RE: 2<sup>nd</sup> Round Pre-App Comments for 200 N Federal Highway, Pompano Beach, FL

**DRC**  
PZ22-12000039  
08/02/2023

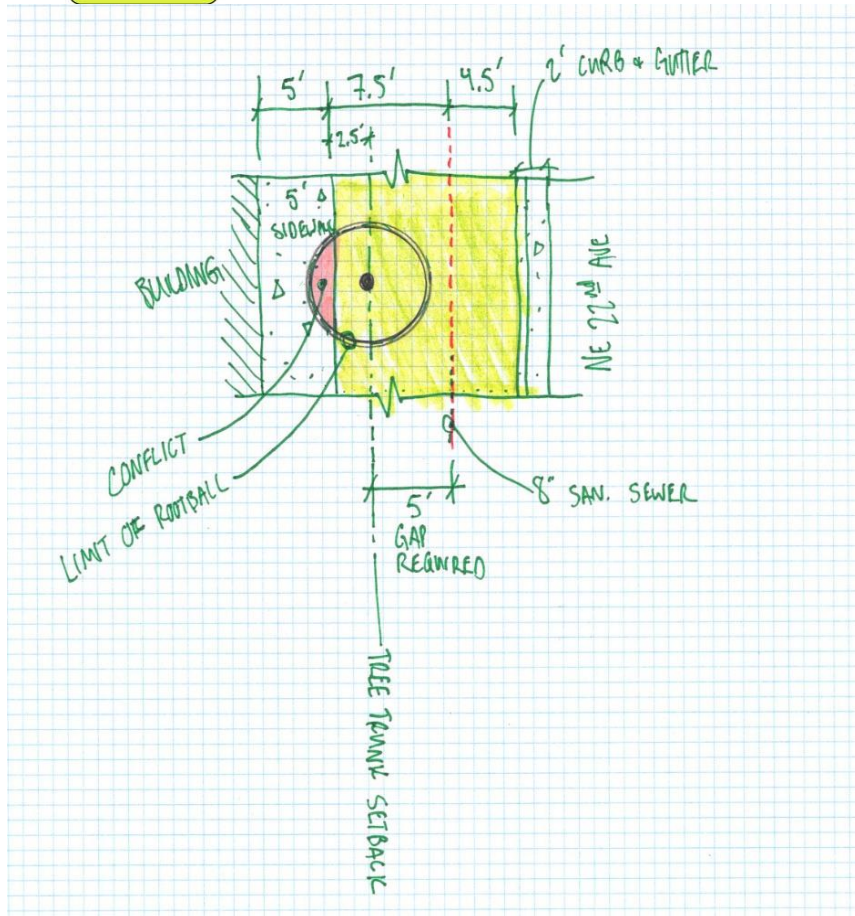
7. Please show the 5 middle trees along NE 22 to be the large Oaks. Silver buttons do not meet the requirements. On street parking is not required, however the trees are, please adjust to meet the minimums and size.

Plans updated to include Oaks along 22<sup>nd</sup> Ave; however, Oaks will need to be field verified prior to installation because even if removing the on-street parking, the 24' there is an 8" Sanitary Sewer running up the middle of the planter that we need to be 5' away from (as required by Utilities review). Large, 24' Oaks might not have rootballs that will fit. Oak rootballs need to be small enough to have a rootball under 5' wide. Here is a sketch to illustrate the problem (1/10"=1'-0" grid FYI):
